PRELIMINARY LOT LINE REVISION APPROVAL

NOTICE OF DECISION

Project Number:	SUB16-004
Description:	The proposal is a request for preliminary approval of a lot line revision between three existing residential lots and a portion of unplatted land.
Applicant:	Jim Dearth Ripple Design Studio, Inc. 1303 Stone Way N Seattle WA 98103
Owner:	Run Yong USA
Site Addresses:	8375 and 8383 E Mercer Way, Mercer Island, WA 98040 Identified by King County Tax Parcel Numbers 0321100145 and 0321100140
Zoning District:	R-8.4 and R-9.6
Exhibits:	1. Preliminary Lot Line Revision plan set prepared by Edwin J. Green, P.L.S. of Terrane, dated September 16, 2016. 2. Project application form dated May 10, 2016 3. Letter from Patrick Mullaney, Foster Pepper PLLC dated September 28, 2016

LOT LAYOUT
NW 1/4, NW 1/4, SEC 31, T 24N, R 5E, W.M.
RUN YONG USA
8375 & 8383 E MERCER WAY
MERCER ISLAND, WA

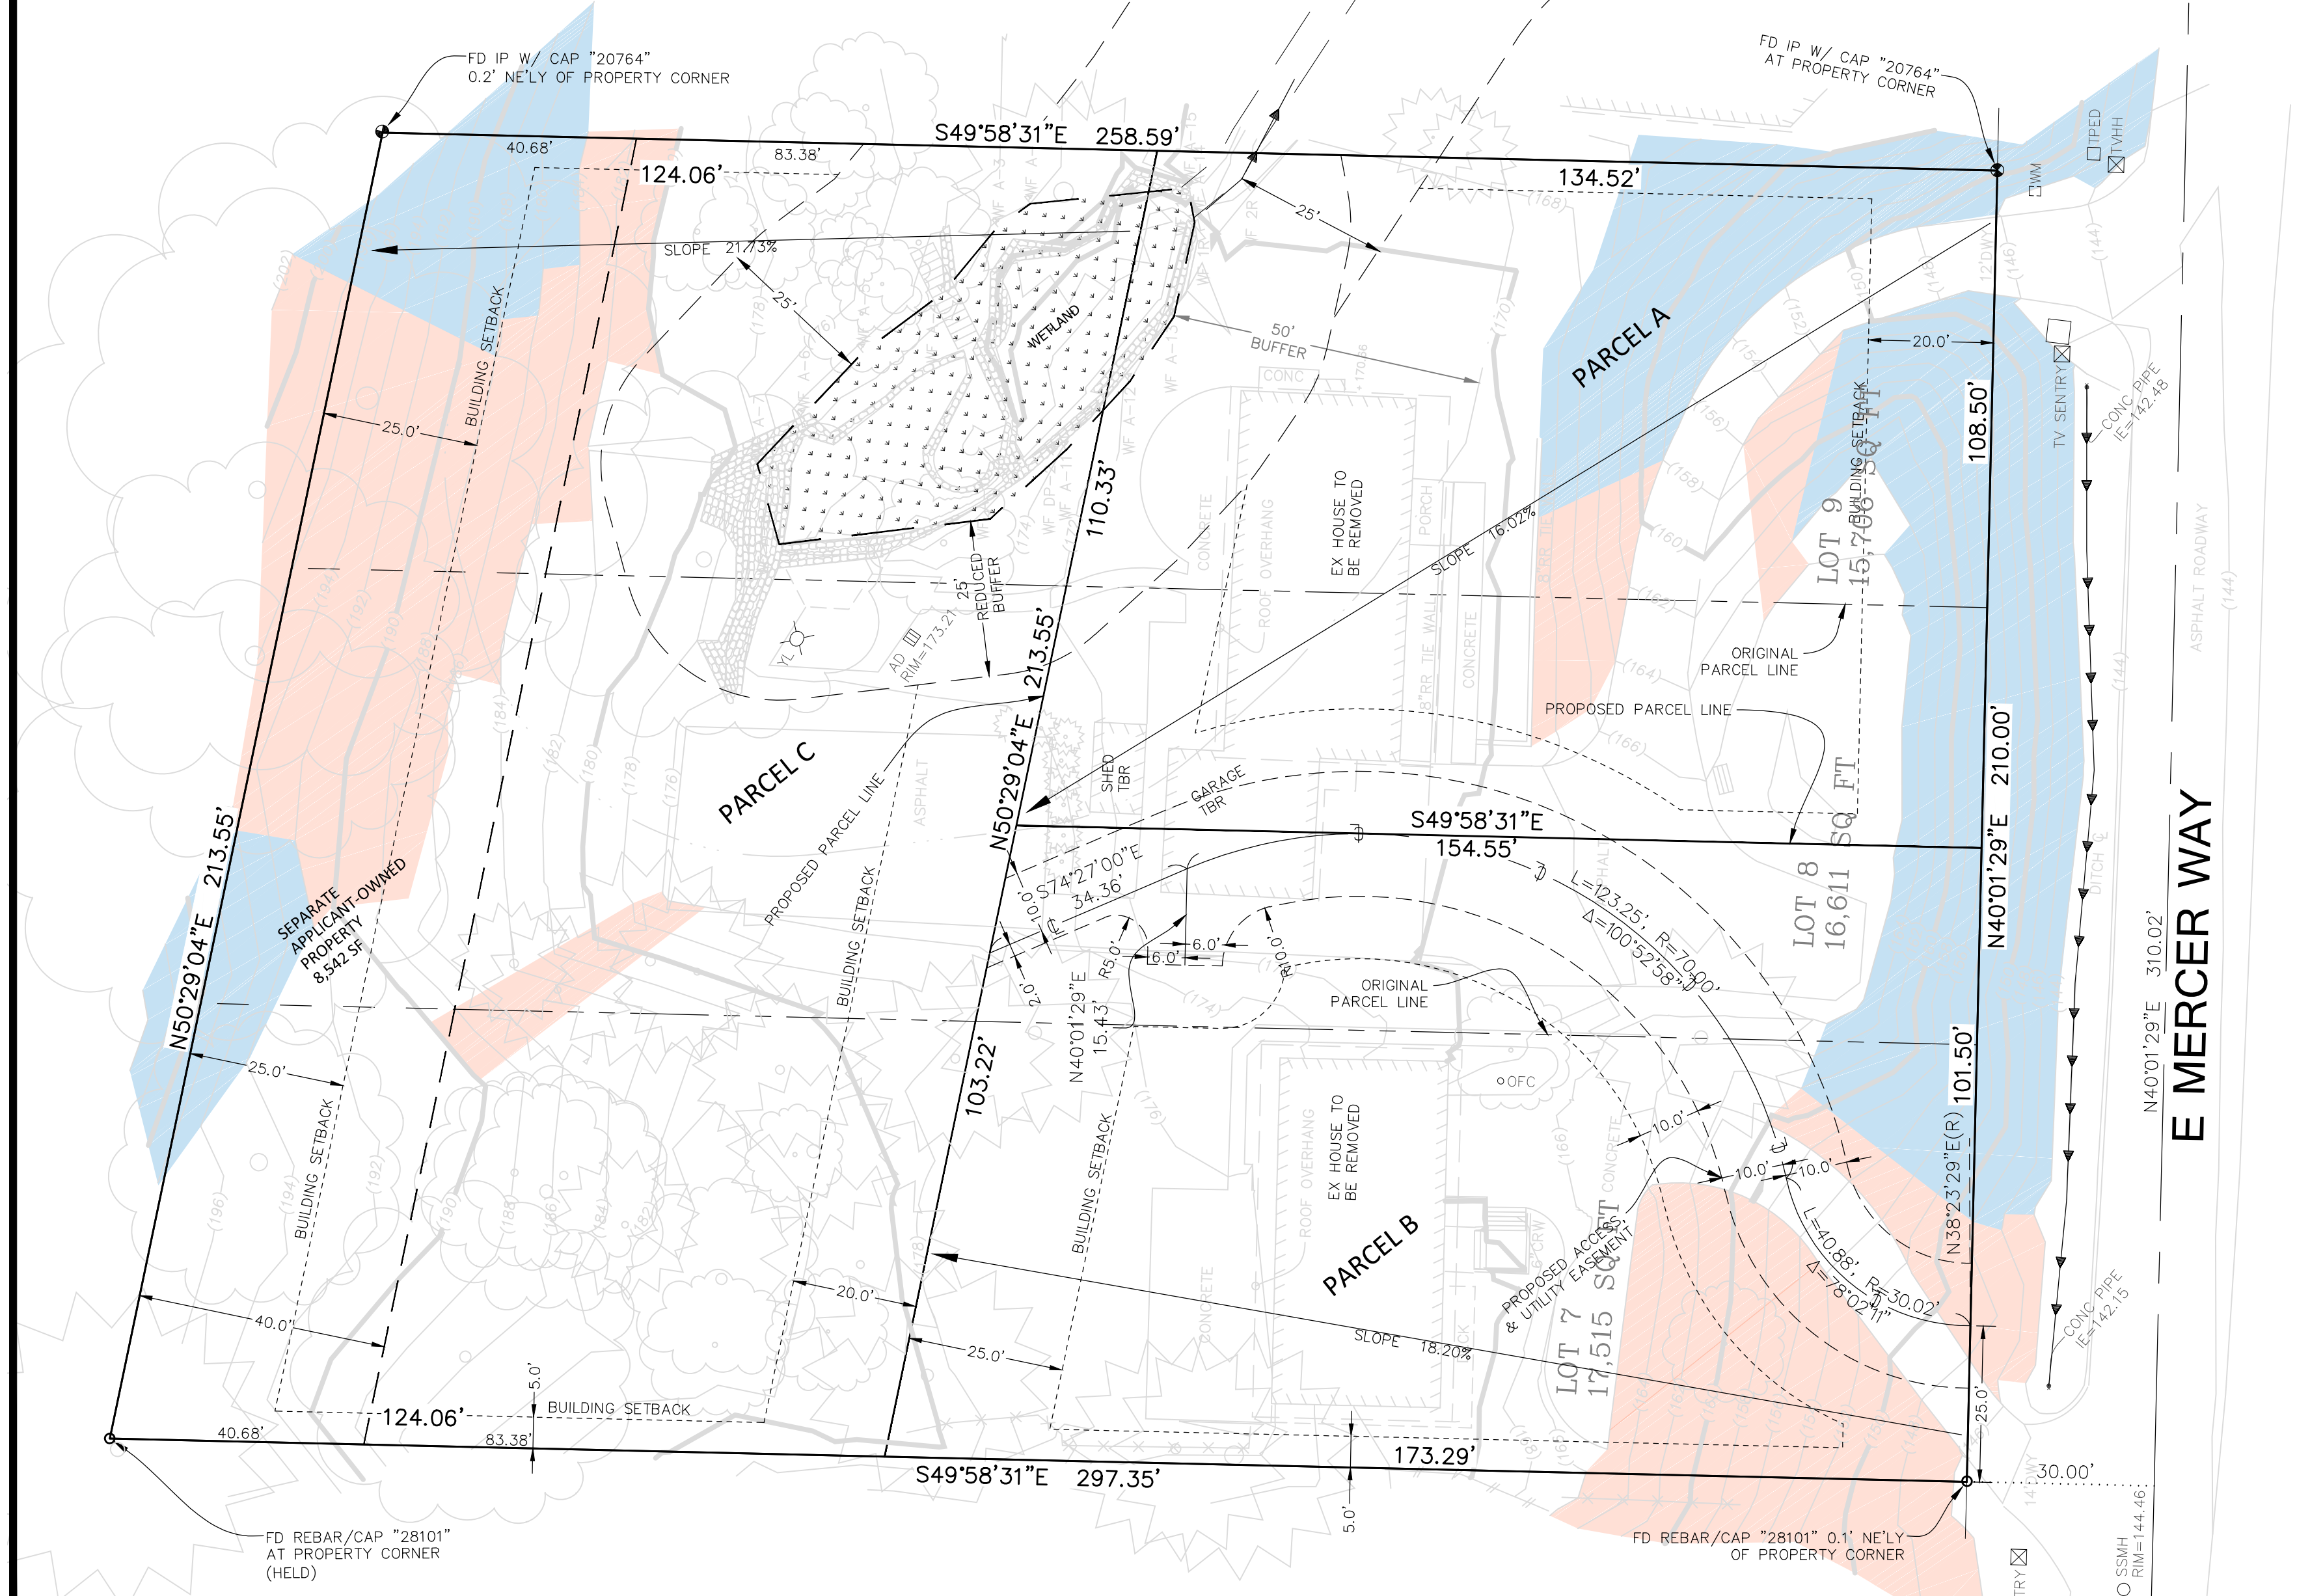
2. Sheet 3 of 4 shall be corrected to remove "wetland buffer" area from the calculation of net area, in order to remain consistent with MICC 19.02.020(A)(2).
